Groundwater Application Review Summary Form

Application # G- 18614

TO: Water Rights Section Date 10/2/2018
 FROM: Groundwater Section Benjamin Scandella, Dennis Orlovski
 Reviewer's Name
 SUBJECT: Application G-18614 Supersedes review of _____
 Date of Review(s)

A. GENERAL INFORMATION: Applicant's Name: **CHRIS RAMSEY; FOXGLOVE PROPERTIES LLP**
 County: **YAMHILL**

Figure 1: Water-Level Trends in Nearby Wells

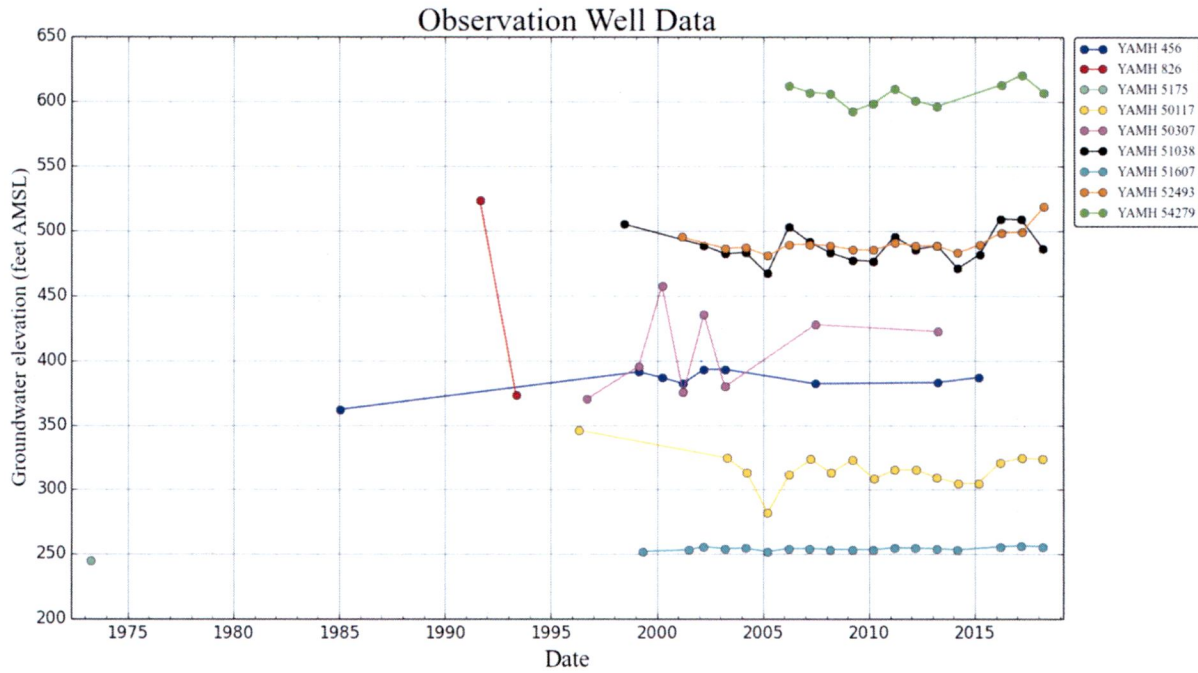
Nearby well logs show typical yields of <50 gpm, with a median of 15 gpm out of 100 wells. The well logs for 2 of the applicant's other wells, YAMH 826 and YAMH 50117, show yields of 3 and 15 gpm, respectively. Therefore, it is unlikely that the proposed well will produce the requested rate of 75 gpm. Water level data from nearby basalt wells with similar water-bearing zones and static water level elevations show relatively stable trends (See Figure 1), suggesting that the resource is not yet over-appropriated. However, condition 7I (Willamette Basin Basalt Groundwater Condition) is recommended to monitor the resource.
